N6736B-01

S E R V I C E N O T E

N6736B 50W DC Power Module

Location of C36 and C37

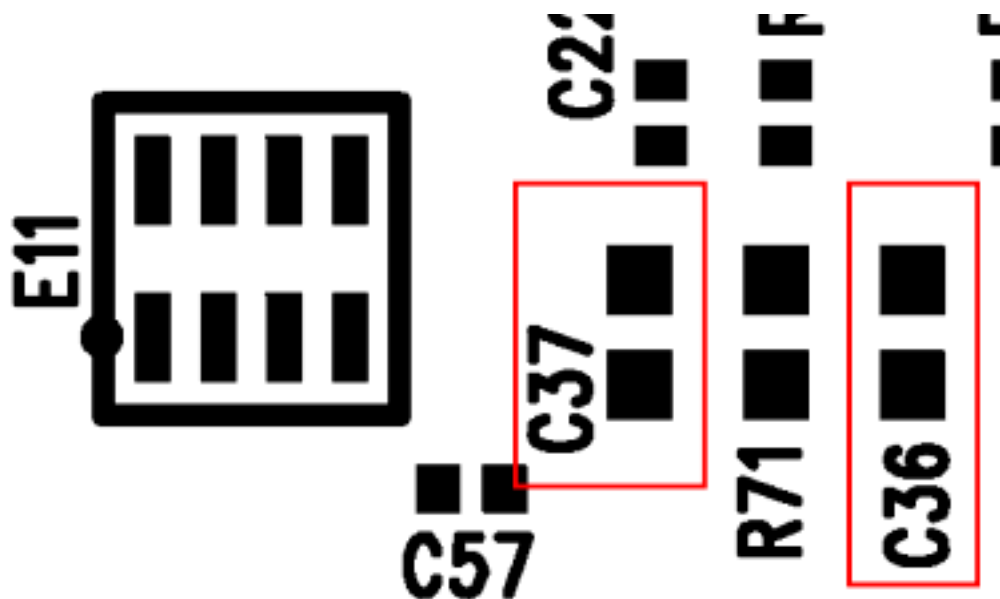
Due to some noise filtering issues, the current measurement accuracy will be out of specification by a fixed offset when there is a voltage being sourced at the output terminals. If the output is shorted, the current measurement accuracy will be within specifications. Please note that the performance verification test will not catch this.

If this measurement is out of specification, replace capacitors C36 and C37 on the DPM assembly (this is the assembly that is vertically mounted in the unit that looks similar to a PC memory module) with part number 0160-7809. After the capacitors are changed, the unit will require re-calibration. After the capacitors are replaced, check the make sure that the unit is in specification by applying 75% of the full voltage range while attached to a load drawing 50 mA to 70 mA. If the current measurement is within the specification, then the unit has been repaired.

Test to see if the module is out of specification by applying 75% of full scale voltage while drawing 50 to 70 mA . Compare the reading to what it should be via the current measurement accuracy spec. If the current measurement is within specification then the capacitors will not need to be changed.
